Access Compliance Report

Public Rights-of-Way

(Curb Ramps)

Intersection ID: 9339	Main Street: BADGER_CT	Cross Street: WOODWARD_AV	Location: SW
ADA ID: BC0482756D7D	Ramp Type: Perp	Initial Pass/Fail: Fail	Overall Compliance: No
		Severity Score: 12.5

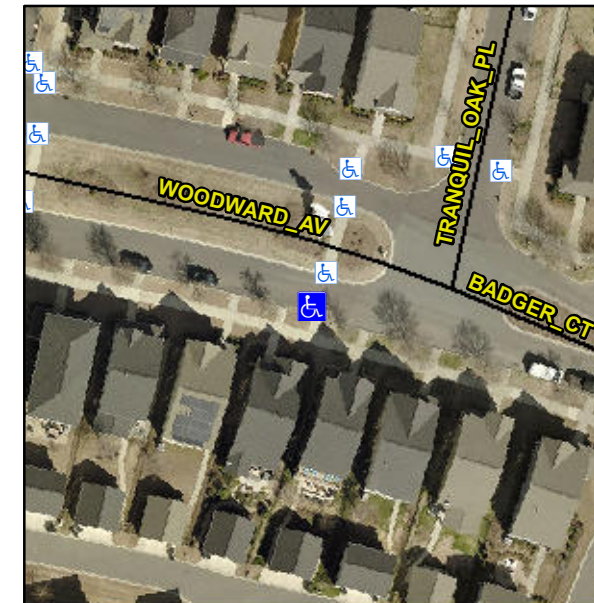
Not Found, R304.5.3

Compliance	Description	Data	Compliance	Description	Data
N/A	Ramp Length (in)	176.0	Yes	Ramp Slope (%)	6.9
Yes	Ramp Width (in)	52.5	No	Ramp XSlope (%)	5.2
N/A	Flare Type LT	N/A	N/A	Flare Type RT	N/A
N/A	Flare Slope LT (%)	N/A	N/A	Flare Slope RT (%)	N/A
N/A	Flare Traversable LT?	N/A	N/A	Flare Traversable RT?	N/A
N/A	Landing Length (in)	N/A	N/A	DWS Provided?	N/A
N/A	Landing Width (in)	N/A	N/A	DWS Contrast?	N/A
N/A	Landing Slope (%)	N/A	N/A	DWS Length (in)	N/A
N/A	Landing X Slope (%)	N/A	N/A	DWS Full Width?	N/A
N/A	Landing Curb? (Y/N)	N/A	N/A	DWS Offset (in)	N/A
N/A	Shared Landing?	N/A			
N/A	Gutter Ponding?	N/A	N/A	Gutter Slope (%)	N/A
N/A	Gutter Lip Ht (in)	N/A	N/A	Gutter X Slope (%)	N/A
N/A	Painted X Walk1?	No	N/A	Painted X Walk2?	N/A
	X Walk 1 Direction	To N		X Walk 2 Direction	N/A
N/A	X Walk 1 Width (in)	N/A	N/A	X Walk 2 Width (in)	N/A
	X Walk 1 Slope (%)	2.2		X Walk 2 Slope (%)	N/A
	X Walk 1 X Slope (%)	4.3		X Walk 2 X Slope (%)	N/A

Remove & Replace Entire Ramp.
